FINAL  
DRAINAGE PLAN AND REPORT

**A PROPOSED CHURCH AT 10695 LINDBERGH ROAD  
AN UNPLATTED LOT**

County Fil No.: PPR-20-048

Revised  
January 26, 2022

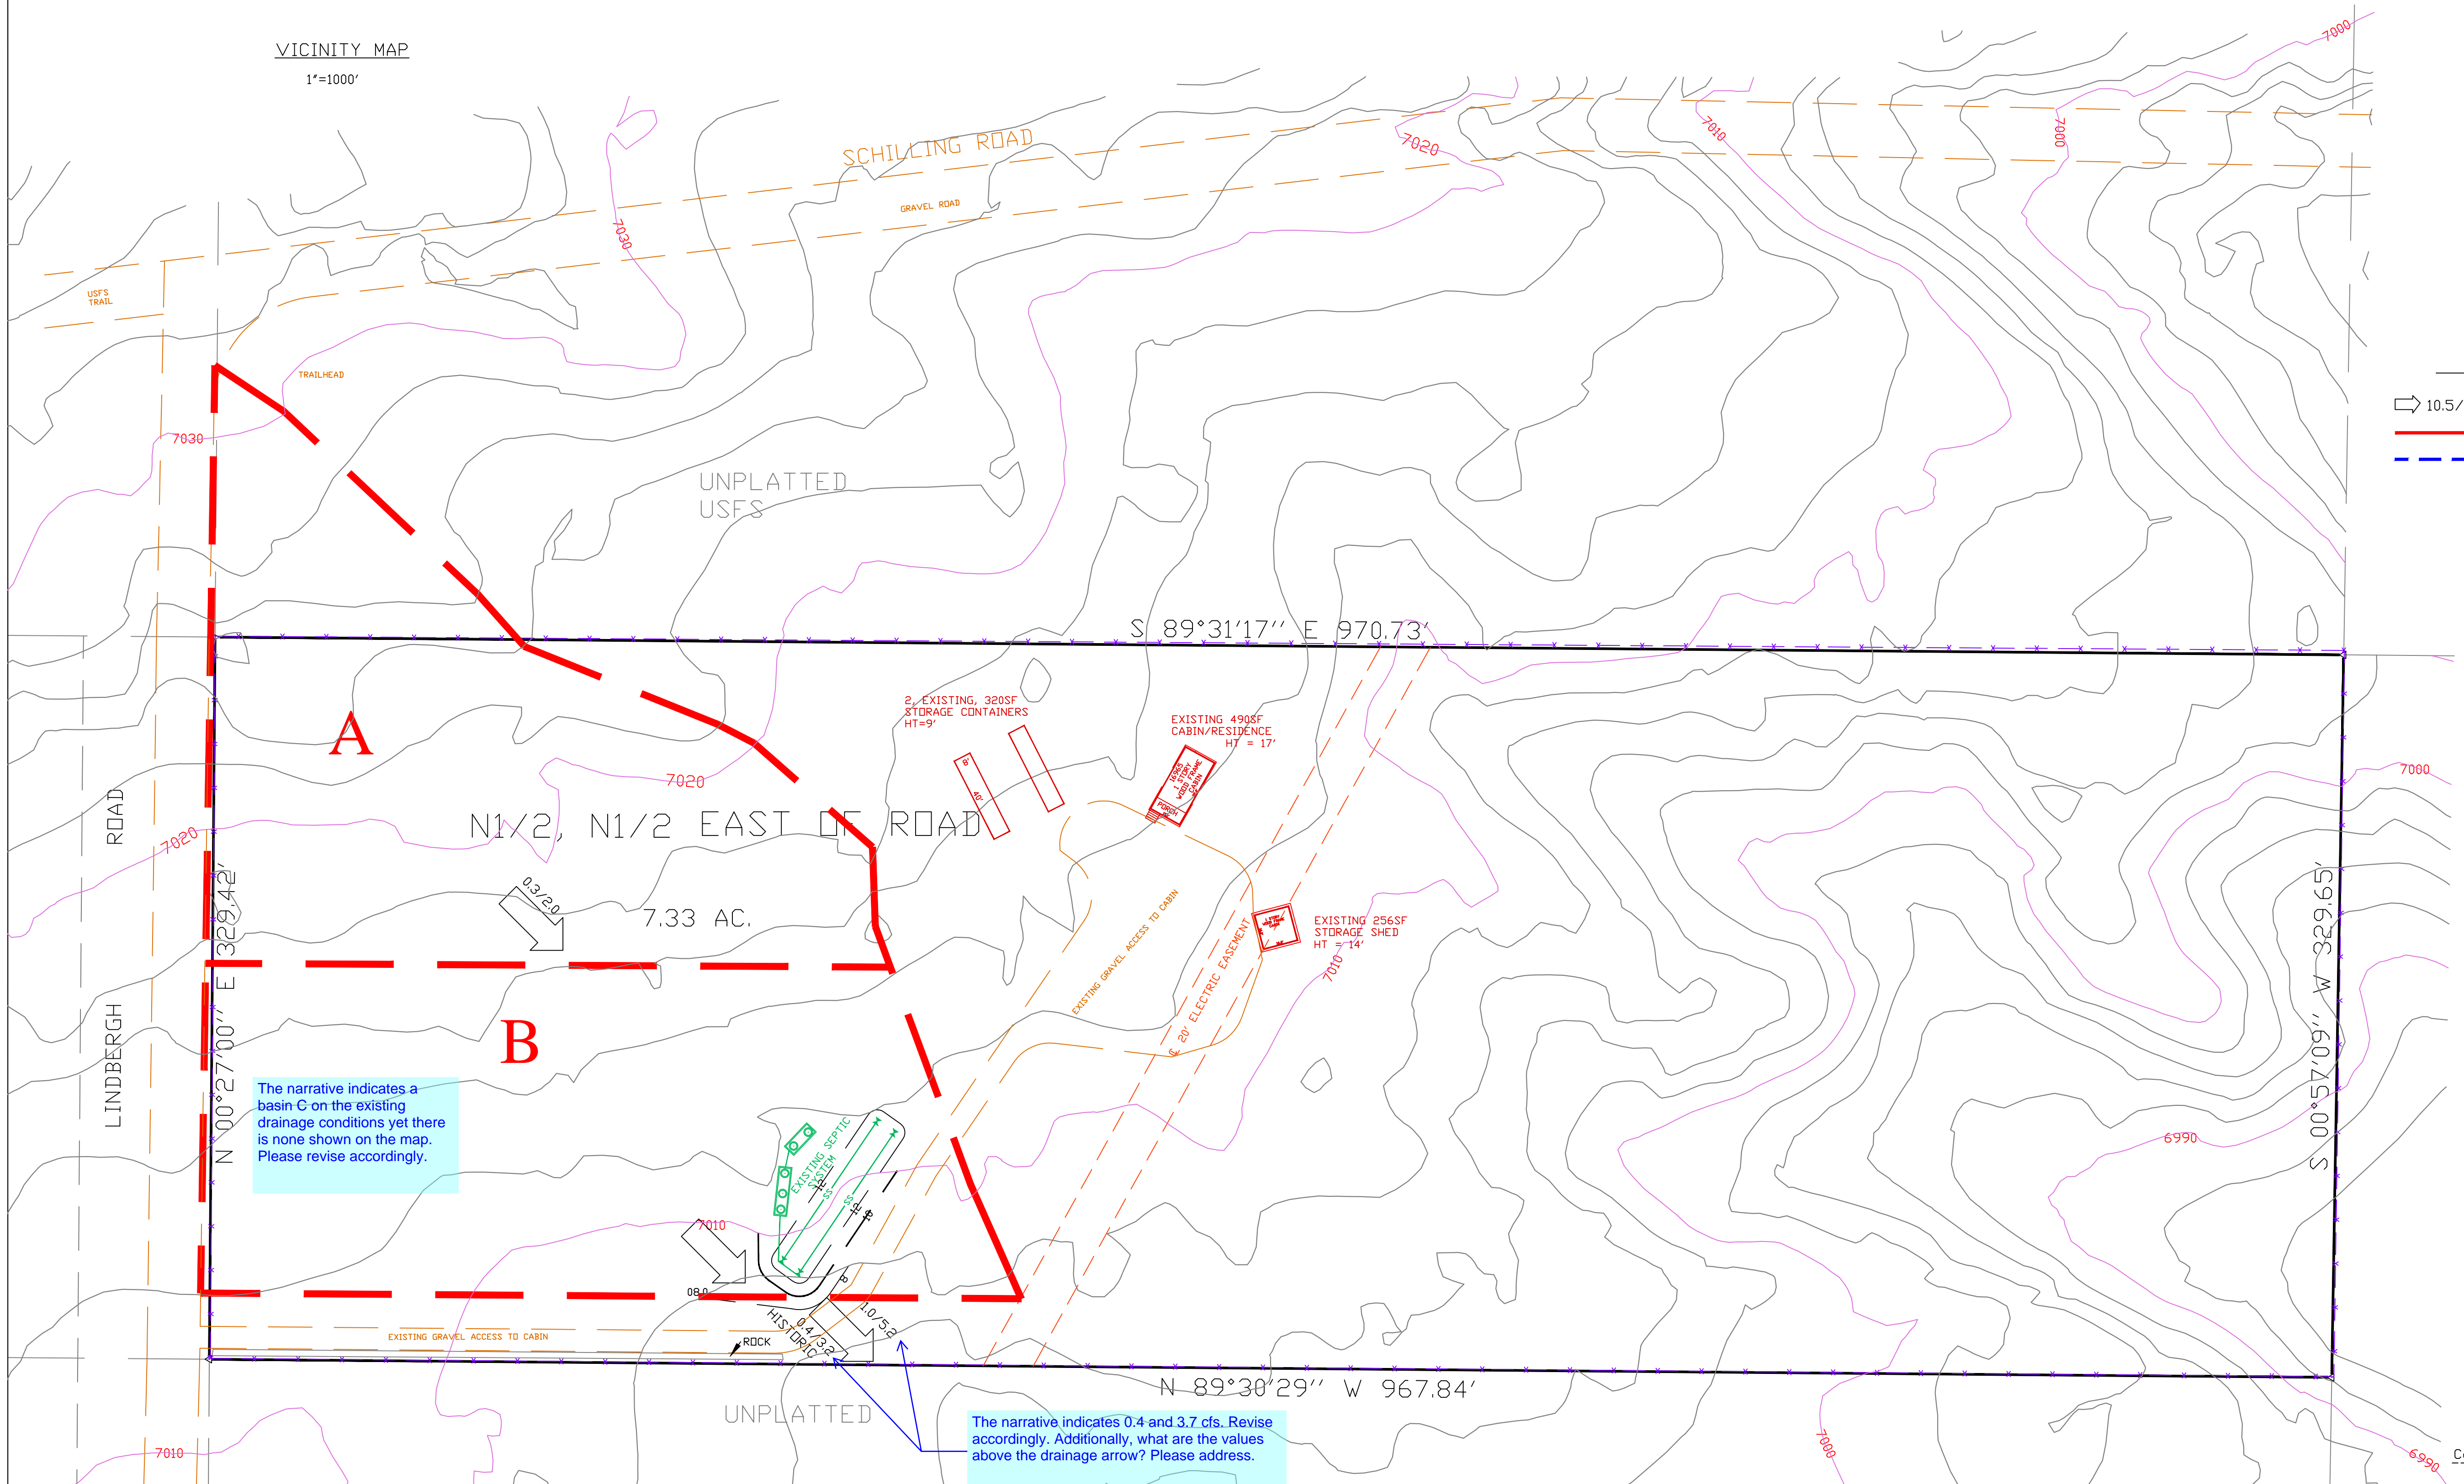
The narrative indicates a basin C on the existing drainage conditions yet there is none shown on the map. Please revise accordingly.

The narrative indicates 0.4 and 3.7 cfs. Revise accordingly. Additionally, what are the values above the drainage arrow? Please address.

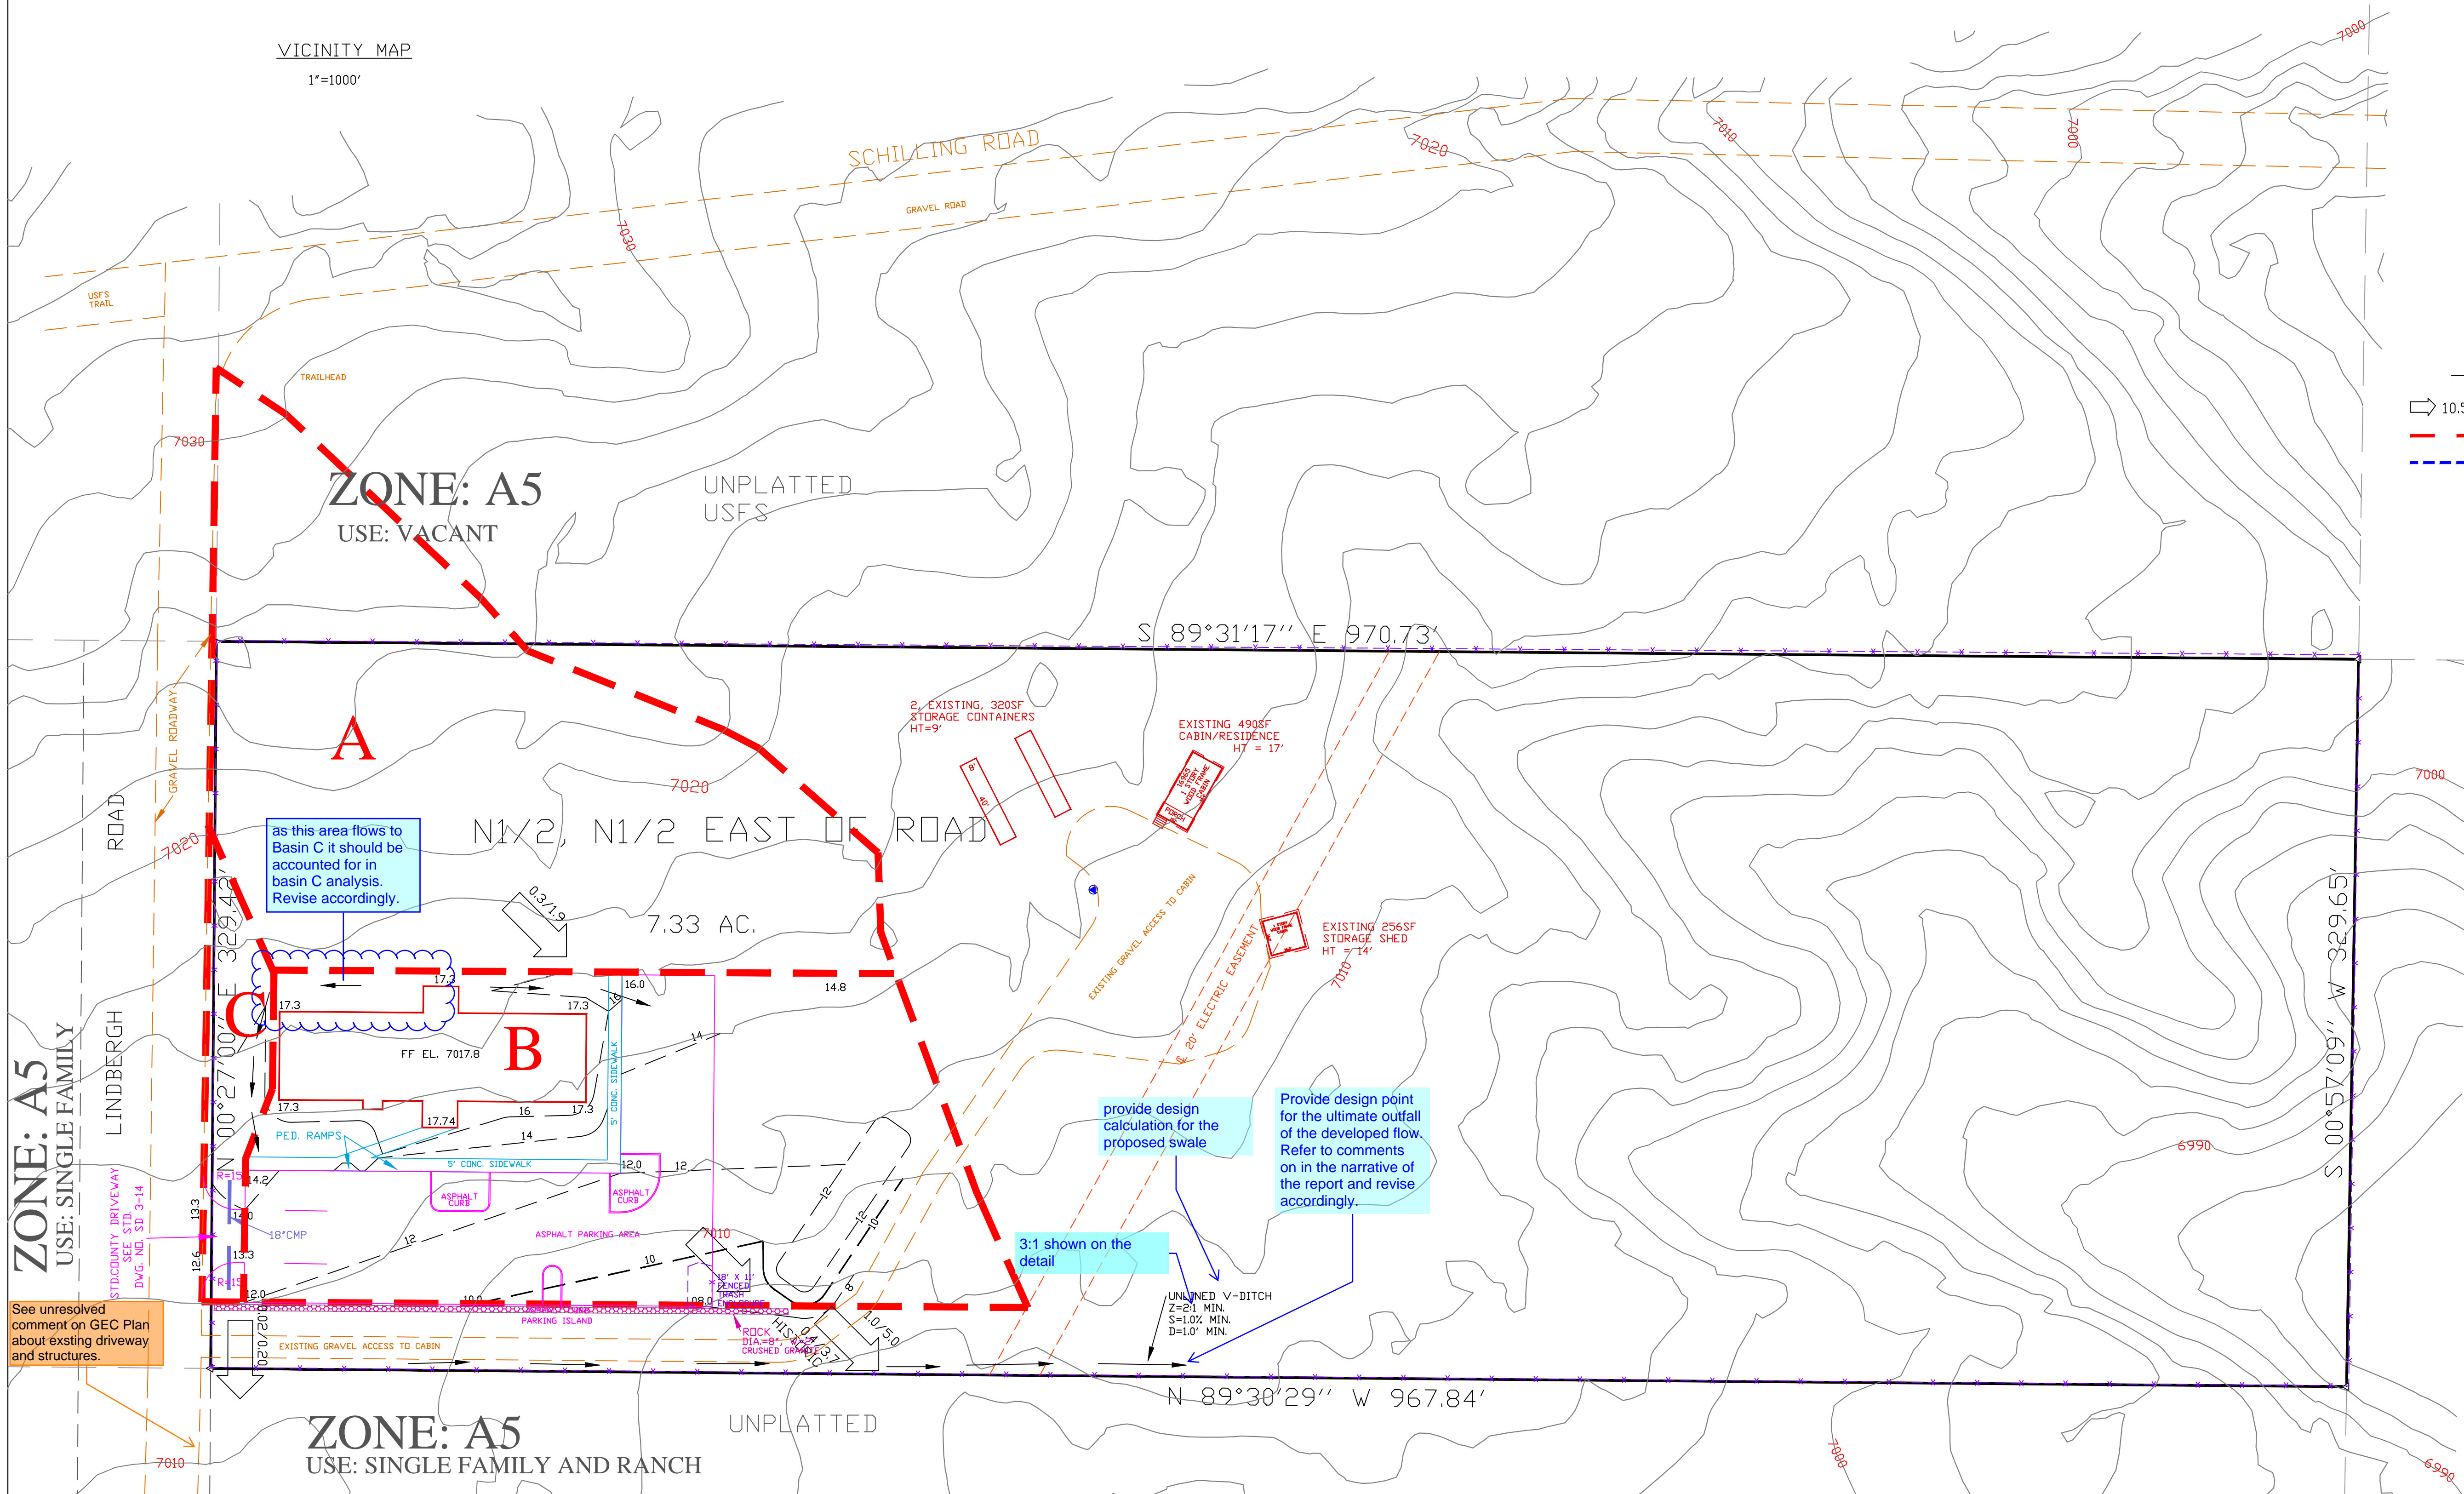
Please identify the outfall of the proposed swale and indicate a design point with flows at this location. Compare the developed flows at this location with historic flows.

By providing a swale to prevent runoff to the southerly lot, the runoff has been concentrated. Please indicate how the increased flow and now concentrated flow at the ultimate outfall will be mitigated so that it does not negatively impact the downstream or surrounding properties. Please also discuss what the existing downstream conditions are.

The outfall point has changed now that the ditch on the southern boundary is shown.

It does not appear that the diverted flow from the back of the building was accounted for in Basin C. Please revise accordingly.
